MINATO MARU / ENGINE ROOM H1

JS127-ER-H1-03 | CAD implementation amendment | 31 October 2026

CURRENT MODEL SURVEY + ENGINEERING REVIEW

Mechanical workshop, engine store and electrical workshop

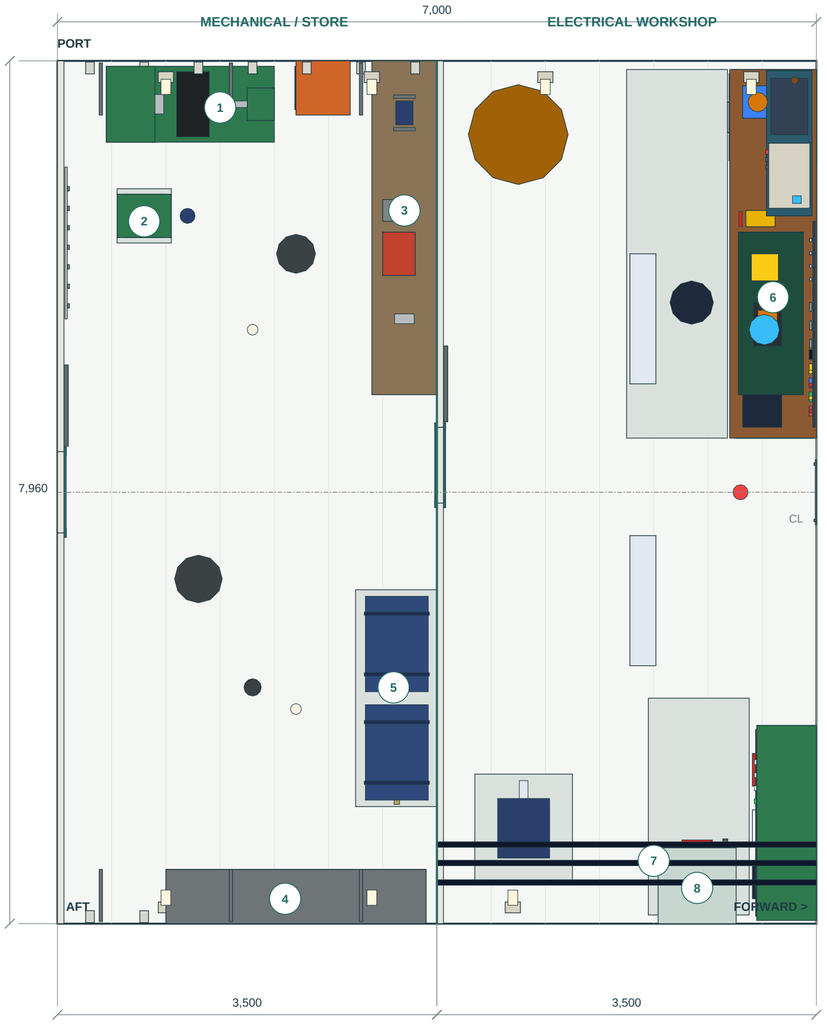
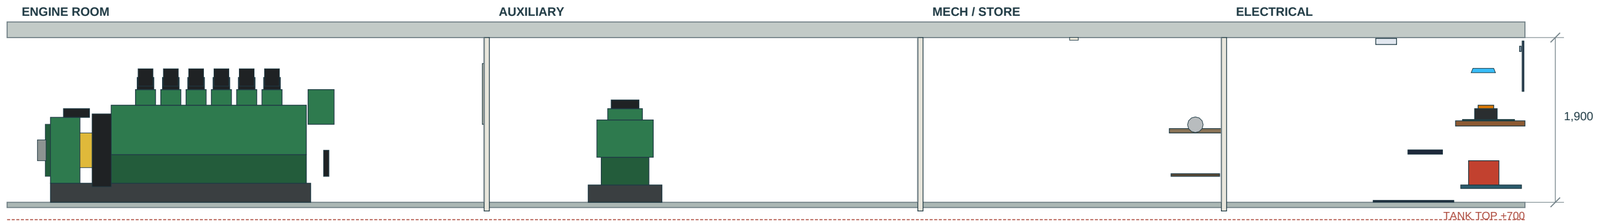
Lathe, pedestal drill, main bench and vice remain. Welding set and grinder remain in the room; hot-work control, screens and extraction are not established by the model.

Spares racks, two oil drums and chain block remain. Mesh partition retained. A stored chain block is not a designed lifting beam or a complete engine-removal scheme.

Existing trunk at X=24,600-25,200 remains. Its through-deck continuation and hatch still need detailing. Do not treat the store as a protected safe escape location.

A-A / port machinery centre plane, Y=+1,550

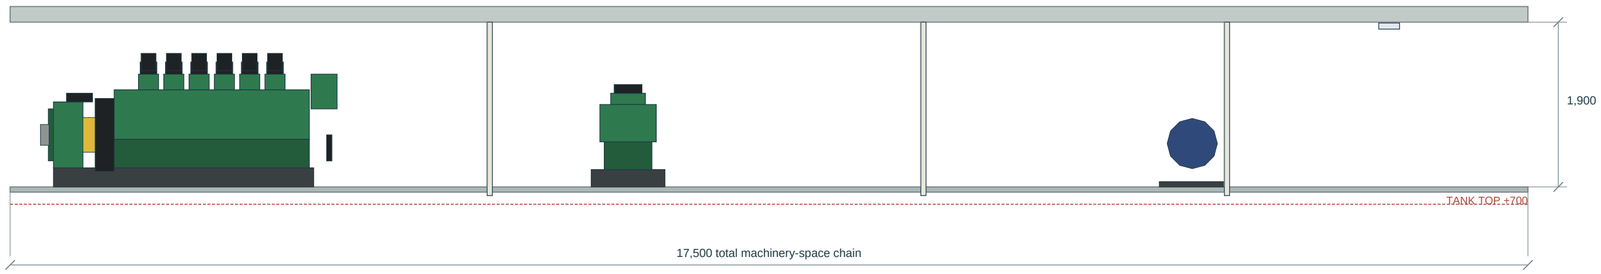
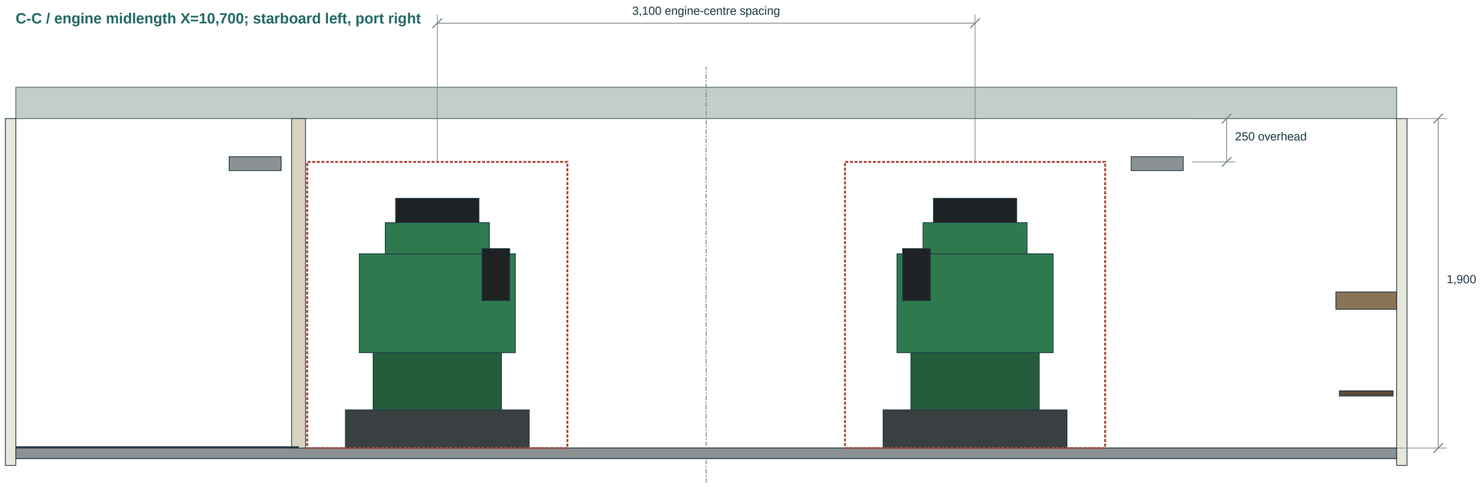
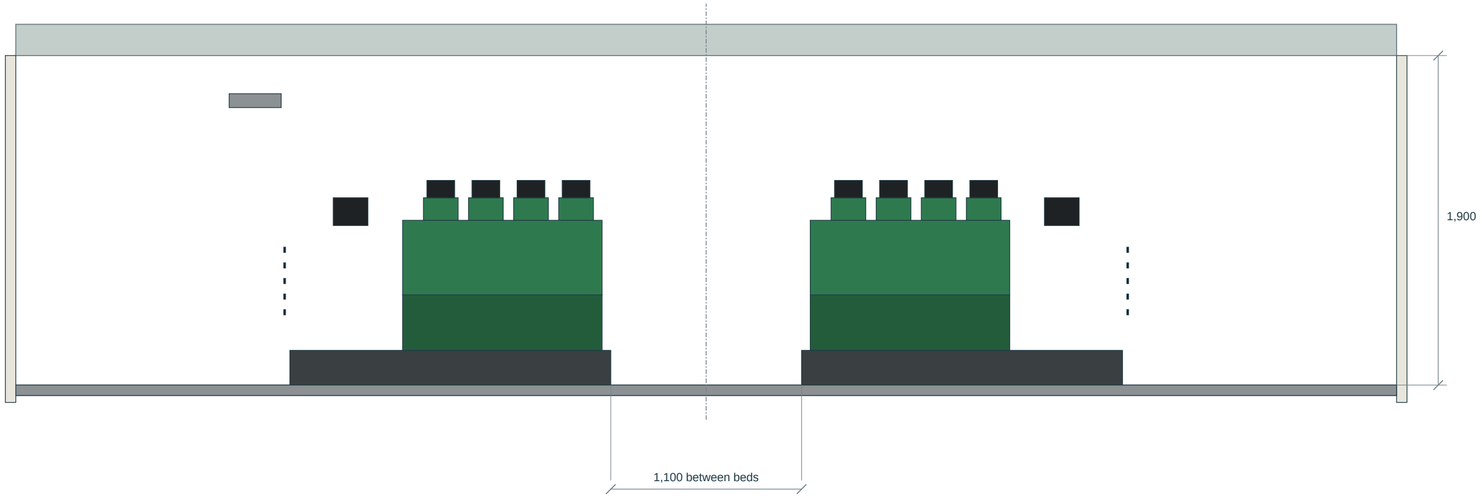
The source hull and loading assumptions remain unreconciled. Do not lower the machinery floor, deepen tanks or move bulkheads to manufacture clearance without rechecking hull shape, structure, weights and stability.

The source grating sits at about +906, on the working-floor level. The 200 mm tank-top interval is service depth, not a walkable lower machinery deck.

The M1 reference reservation rises to +2,550, leaving 250 mm to the deckhead. Piston/liner withdrawal and chain-block hook height are unknown.

Deck beams, tank-top girders, foundation bolts, resilient mounts and lifting points are not fully engineered. The 180 mm model deckhead is an envelope, not an approved beam design.

A 2,000 mm clear route-height target cannot fit inside the existing 1,900 mm nominal room. Actual piping/trays reduce this further. Do not hide the conflict with a smaller avatar.

Centre aisle is 1,260 mm between actual rail faces. Side access must be checked against fittings, control-booth glazing, valve swing and required part withdrawal, not just a body capsule.

Main engine / recognisable machinery and controlled interfaces

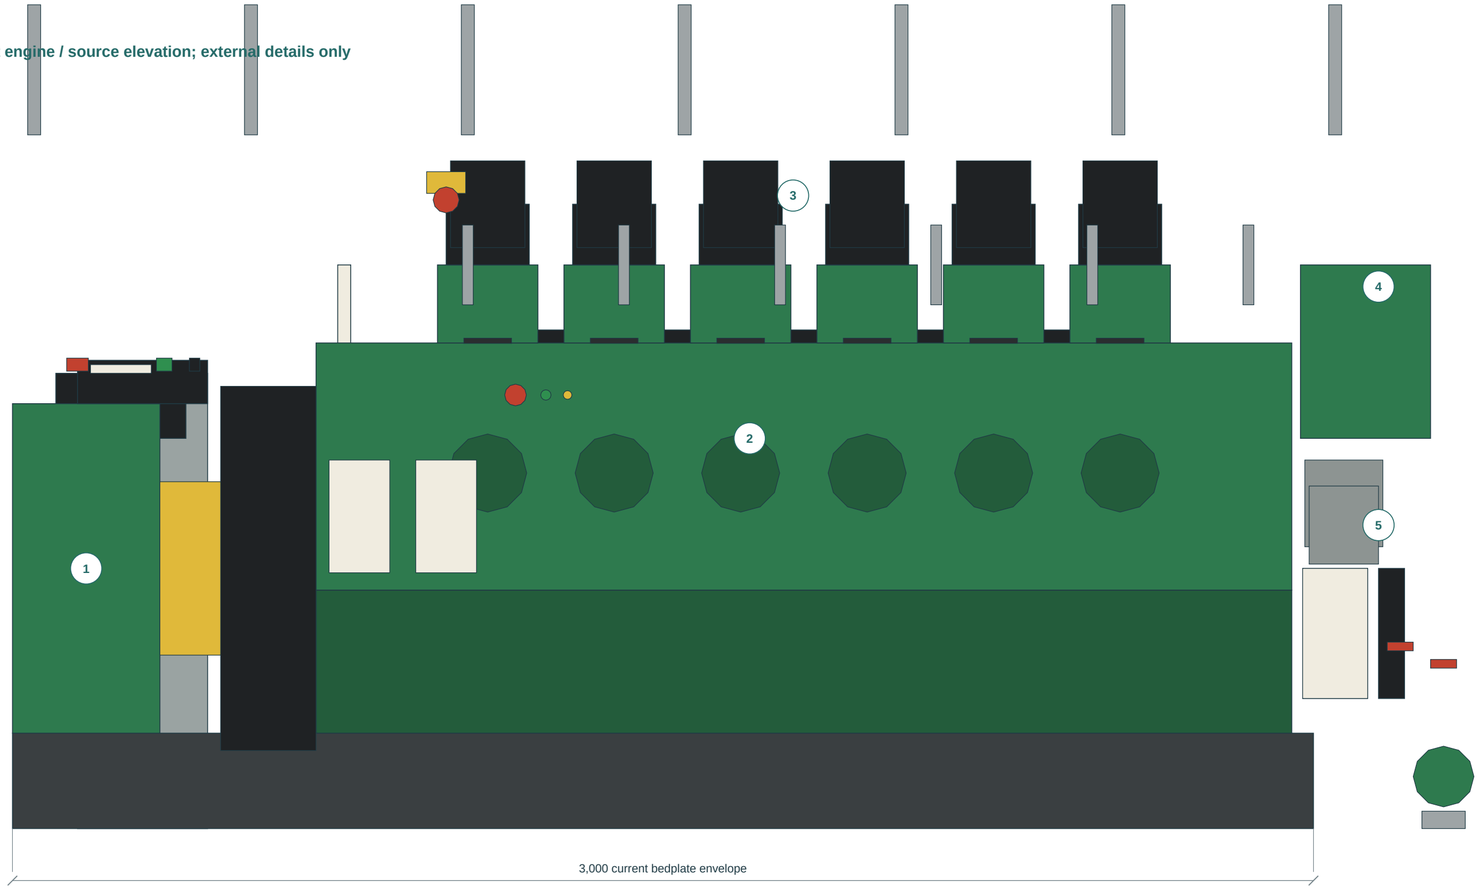
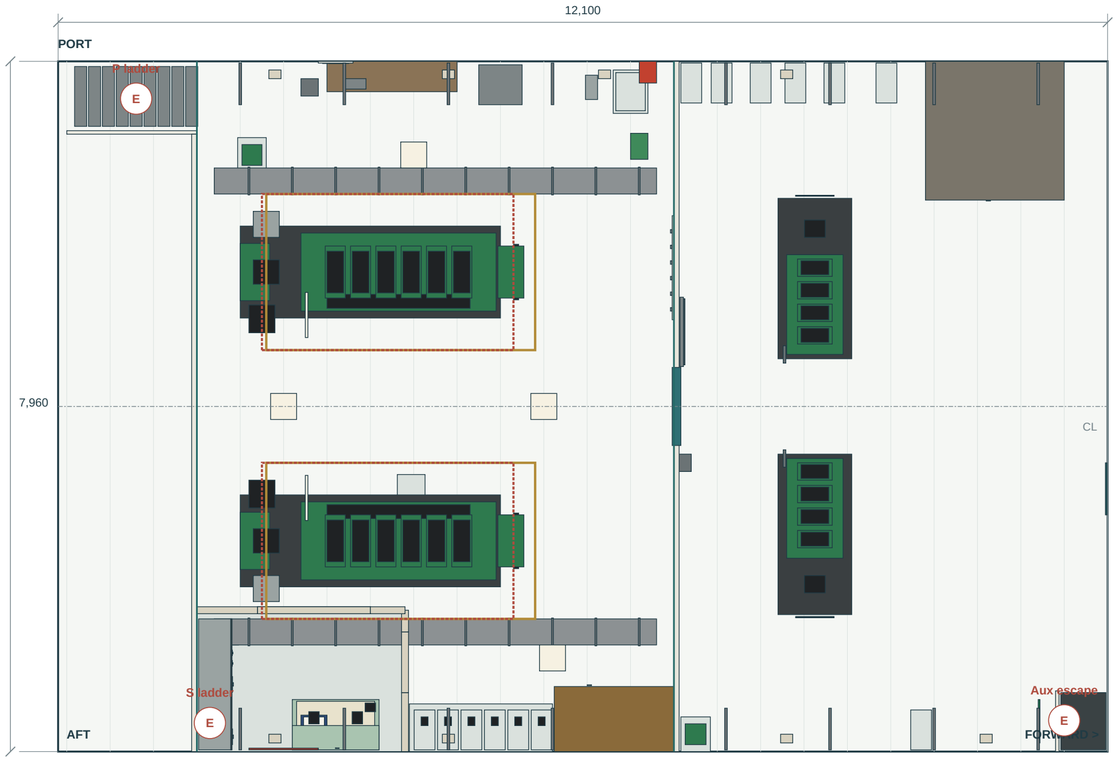
Gear aft, flywheel/coupling between block and gear; propeller shaft leaves aft. Confirm output height, thrust reaction and coupling guard from selected equipment.

Six rocker covers, crankcase service doors, injection equipment and lagged exhaust must read as one coherent machine. A permanently open crankcase cover is inappropriate for the running state.

Turbocharger forward, charge-air cooler and engine-mounted pumps; starting-air, fuel feed/return, LO and cooling connections must each have a separate functional interface.

Drawing decision: retain installed count, purpose and shaft orientation. Obtain a period-credible matched engine/gear installation basis before replacing the fictional envelope with a detailed production asset.

Port ladder / actual rise and run

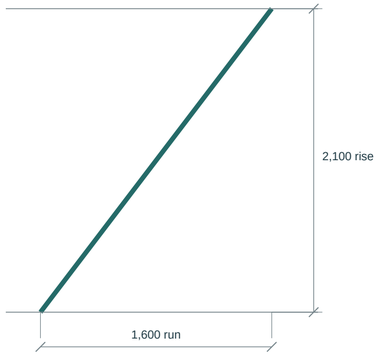
750 mm ladder width. This is a geometric screen only; hands, hatch, head clearance and protected route are unresolved.

Trace both exits from the lowest occupied level to an unobstructed safe deck, including closed-door states. Current aft S ladder has 400 mm rung span, but no complete protected trunk is established.

The present booth has one doorway back into the machinery space. Review an independent sheltered way out; do not count a view through glazing, an oil store or a locked room as an exit.

The prior 3.6 t machinery allowance plus 0.4 t rigging is a planning 4.0 t lift only. No beam, padeye, hook-height, open-deck crane path or through-car-deck closure has been proved.

Reserve removal openings only after coordinating vehicle loading, deck girders, watertight/weather closures, hatch handling, shore crane reach and lift stability.

Services coordination / geometry-screened routes and open connections

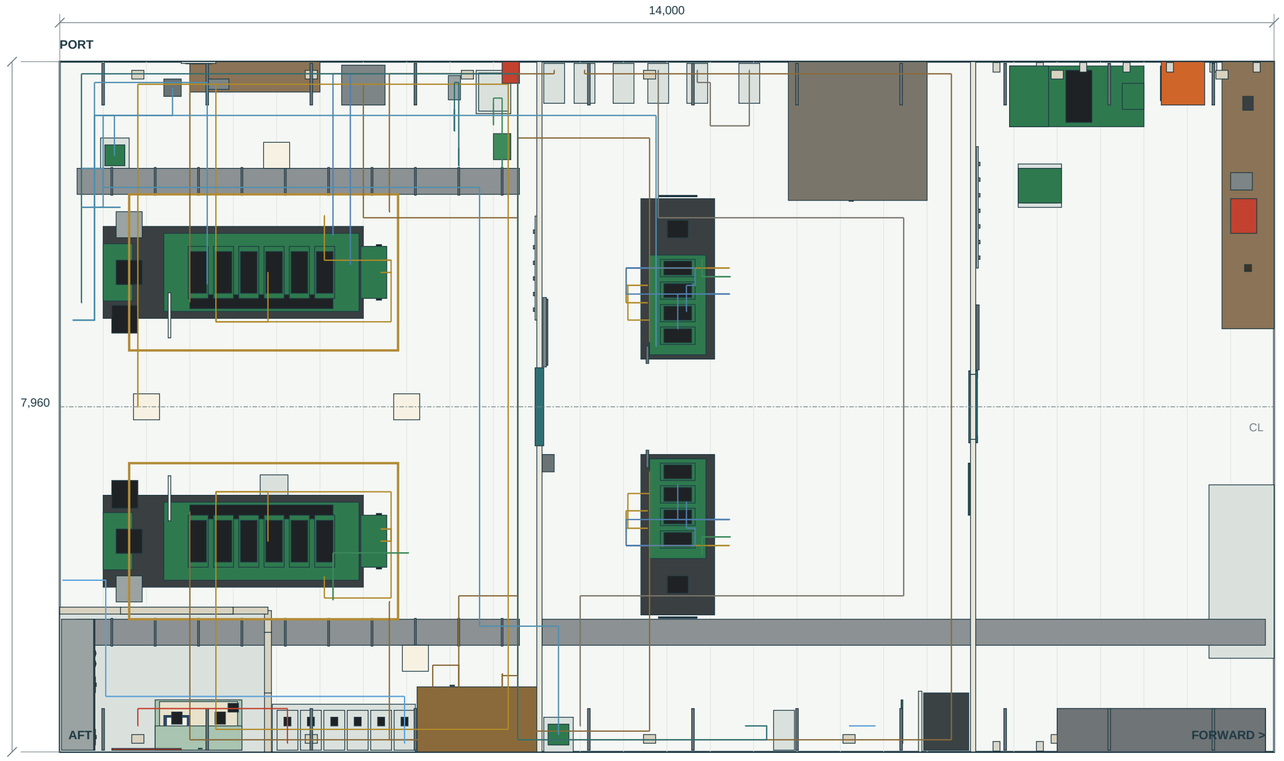
Current main still states 1.8 m gravity head. Model service outlet Z=2,200, engine feed Z=2,050: only 150 mm interface elevation difference, not tank operating head. C1 already removes the unsupported assertion.

For each pipe: identify origin, destination, bore/class, flow direction, valves, drains/vents, supports and bulkhead sleeve. Preserve maintenance and escape envelopes; a coloured line alone is insufficient.

Prove combustion and heat-rejection airflow with ducts and dampers; thermally separate exhaust from oil systems; define protected volumes and extinguishing boundaries before sizing or adding detail.
